WATER QUALITY MEMORANDUM

Utah Coal Regulatory Program

RE: Fourth Quarter of 2013 Water Monitoring, Genwal Resources, Inc., Crandall Canyon Mine, C/015/0032 Task ID #4471

Crandall Mine - Untreated Mine Water - Total Iron Monthly Median

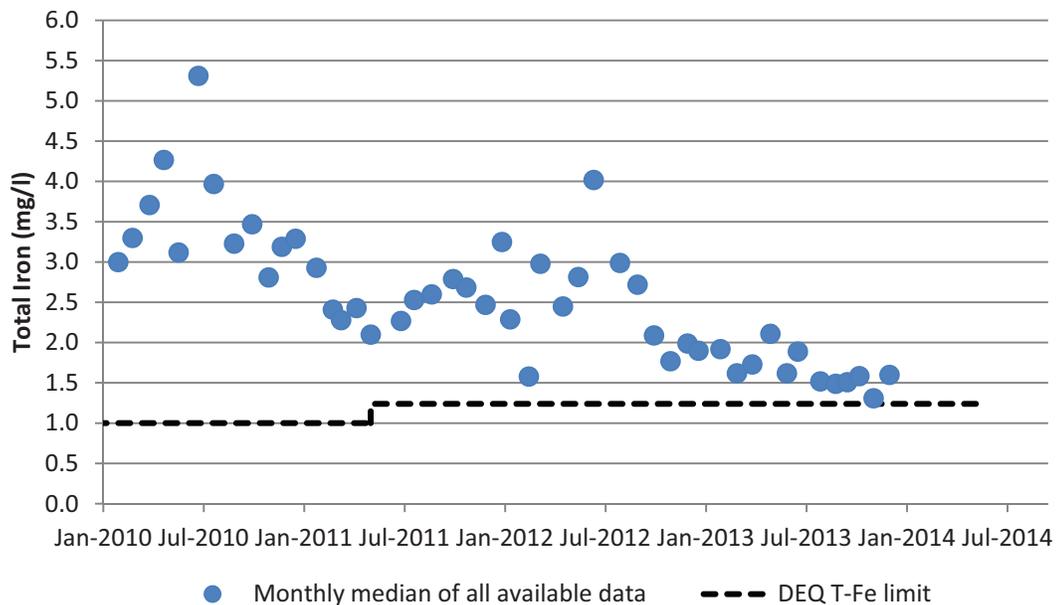
The total iron concentrations in the pre-treatment mine water remains above the 1.24 mg/L UPDES limit. Based on three sampling events the resulting concentrations for total iron were 1.35, 1.46, and 1.65 mg/L for October, November, and December, respectively. The data show that total iron concentration still remains variable but since January 2010 to December 2013 a downward trend occurred. Residual polymer testing was conducted by SGS laboratory and determined a level of residual flocculent of 0.17 mg/L, 0.38 mg/L, and 0.28 mg/L for samples collected in October, November, and December, respectively. Below is a graph of the pretreatment total iron concentration shown as a monthly median since January 2010.
